**KNOXVILLE/KNOX COUNTY METROPOLITAN PLANNING COMMISSION
USE ON REVIEW REPORT**

▶ **FILE #:** 1-E-09-UR

▶ **PROPOSED USE:** Church parking expansion

**1-E-09-UR
USE ON REVIEW**

JOR.01

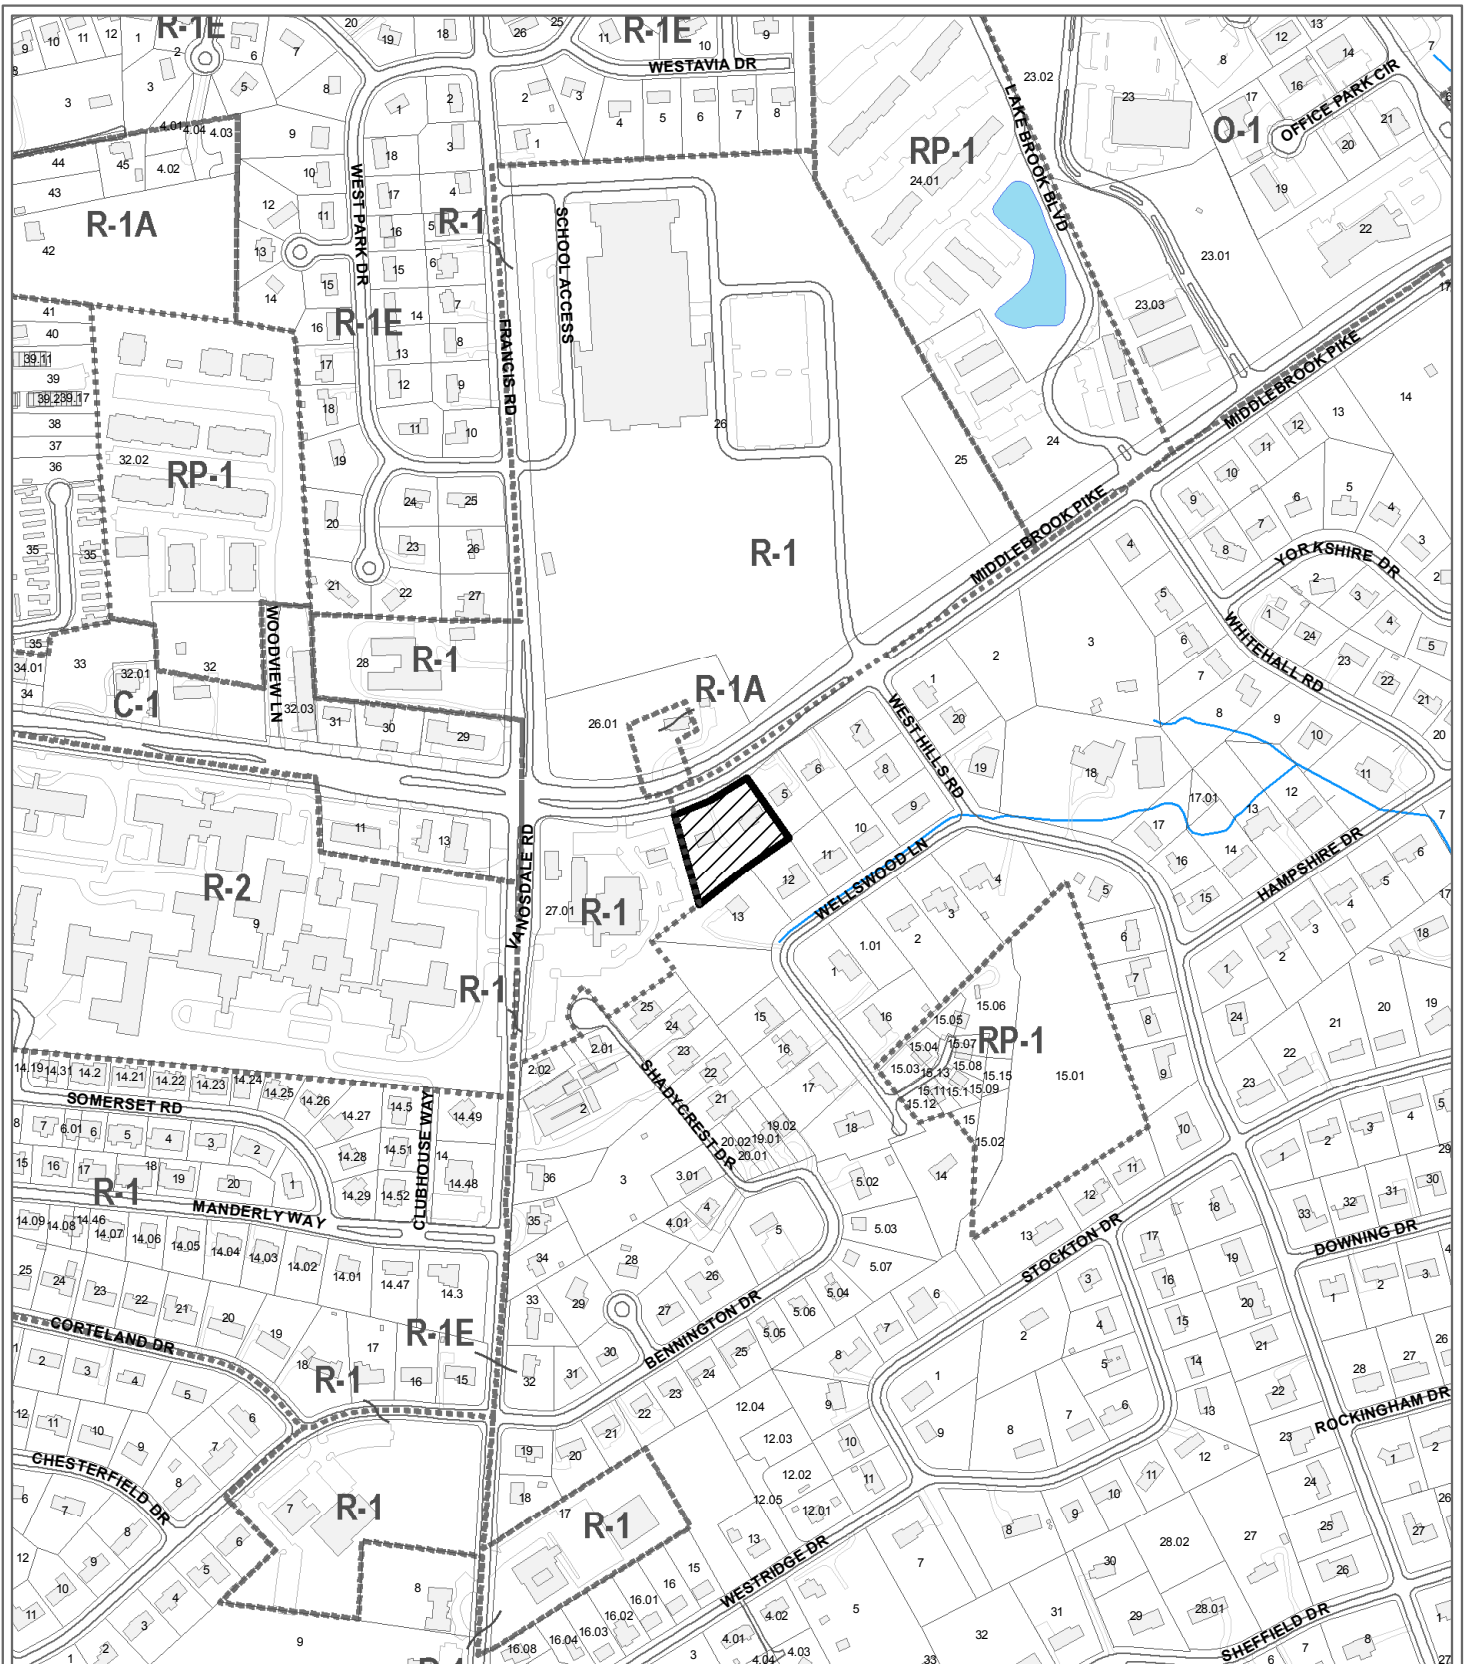
1. Meeting all applicable requirements of the Knoxville Zoning Ordinance.
2. Meeting all applicable requirements of the Knoxville Department of Engineering.
3. Meeting all applicable requirements of the Knox County Health Dept.
4. Obtaining an entrance permit from the Tennessee Dept. of Transportation.
5. Providing and maintaining a 35' landscaped buffer along the southern property line between the proposed overflow parking and the established neighborhood.

6. In addition to the 35' landscaped buffer, planting 6' tall Leyland cypress trees 10' apart along the parking lot and existing tree line to the south of the site.
7. All landscaping shall be installed as shown on the approved site plan within 6 months from the date the parking lots is paved.
8. All lighting shall be directed away from the properties to the south of the site.
9. Meeting all requirements of the City of Knoxville Fire Department.

The applicant is proposing to provide overflow parking for the existing Middlebrook Pike United Methodist Church. The additional 91 parking spaces are to be located on the eastern side of the Church's property. The proposed parking area backs up to an established residential neighborhood. In order to reduce the visual impact on adjoining residences, the applicant has agreed to preserve the existing tree-line along the southern property line, provide additional evergreens between the overflow parking and adjacent residences, and not install any lighting within the new parking area.

The proposed parking lot expansion will access Middlebrook Pike. The applicant will be required to obtain an entrance permit from the Tenn. Dept. of Transportation with regards to the new access onto Middlebrook Pike. Any future development, including modifications to the proposed parking plan, construction of additional buildings, or the placement of temporary buildings, must be reviewed through the MPC use on review process.

I spoke with Harold Cannon who is the project manager. He said that he met with the neighborhood committee in order to develop the notes that we are showing on the plans. The committee had agreed to site lighting for security reasons as long as it was directed away from the properties to the south. We can note that the landscape buffer will be a "visual buffer" with predominately Leyland cypress however; we are not comfortable stating the spacing of the trees until the landscape architect has done a design. The detention has been designed to decrease the runoff from the site to alleviate any existing flooding issues as well as reduce the runoff beyond the requirements of the city.
